RFQ NUMBER DEP13014 1

Addendum to DEP 13014 Okemo / Chafin Pre-bid Conference Questions &

Answers

OFFICE OF SPECIAL RECLAMATION	
SEEP CUTOFF WALL TYPICAL ATTACHMENT	
SCALE:	DRAWN BY:
NOT TO SCALE	MSM
DATE:	PROJECT NO:
12/4/2006	Q-69-82/Q-16-82/Q-16-85

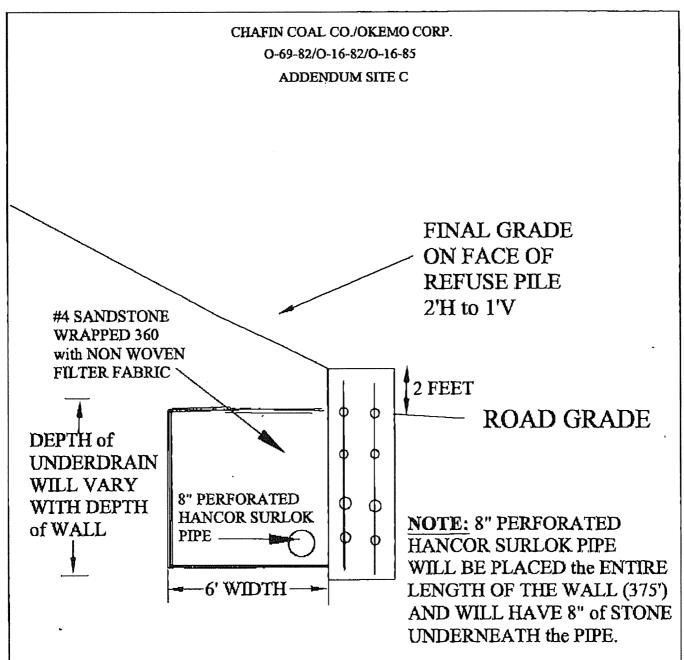
- 19) Q. What is the exposed height of the seep cutoff wall?

A. There will be 2' of the wall exposed next to the road (10/4).
- Q. Is the wall embedded into the bedrock?

A. Yes, the wall will be embedded 6" into the bedrock.
- 21) Q. Do we chip out 6" of the bedrock for the width of the wall?
 - A. Yes, the wall will be embedded 6" into the bedrock so we can cut off any water seeping along the top of the bedrock.
- Q. Are the power lines active that run along the seep cutoff wall construction area?
 A. There is a transition point below this site where AEP lines terminate and the private line begins. This private line is supposed to be inactive at this point, but this will need to be verified with 'miss utility' prior to the start of construction.
- 23) Q. Can we look at 72" culvert to be relocated?

CHAFIN COAL CO./OKEMO CORP. O-69-82/O-16-82/O-16-85 NOTE: 12" HDPE DR17 PIPE will be PLACED in WALL SO AS TO FACILITATE POSITIVE DISCHARGE (FLOW FREELY) into ALKALINITY CELL 1C and MINIMIZE AMOUNT of WATER RETAINED BY SEEP CUTOFF WALL.. TOP OF GROUND 2 FOOT of WALL EXPOSED 12" HDPE DR17 PIPE to ALKALINITY CELL 1C

OFFICE OF SPEC	IAL RECLAMATION
	TOFF WALL ATTACHMENT
SCALE:	DRAWN BY:
NOT TO SCALE	MSM
DATE:	PROJECT NO;
12/4/2006	O-69-82/O-16-82/O-16-85

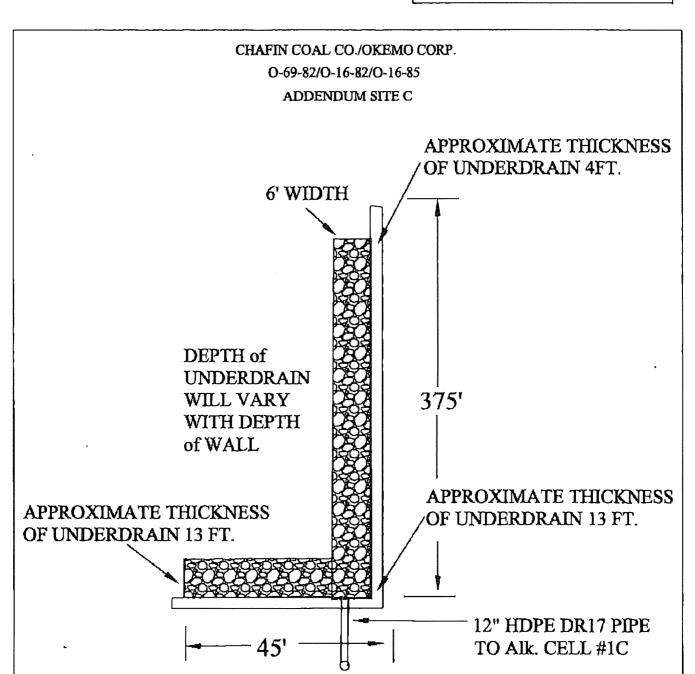
- Comment There is a small sump with culvert that will need to be eliminated on the north end of Site D.
- 14) Q. How wide is the sandstone fill area behind the seep cutoff wall?

- A. This will be answered in the addendum that will be sent out to all attending contractors.
- 15) Q. Do we excavate to a 45' width the entire length of the wall?

- A. This will be addressed in the addendum as well, but we don not want the tow of the refuse pile cut out and left hanging.

NOTE: TOP of Wall will be COVERED with SOIL when FACE of REFUSE PILE is REGRADED and VEGETATED. #4 SANDSTONE will BE WRAPPED 360 degrees with A 1 FOOT OVERLAP of EACH SECTION of NON-WOVEN FILTER FABRIC.
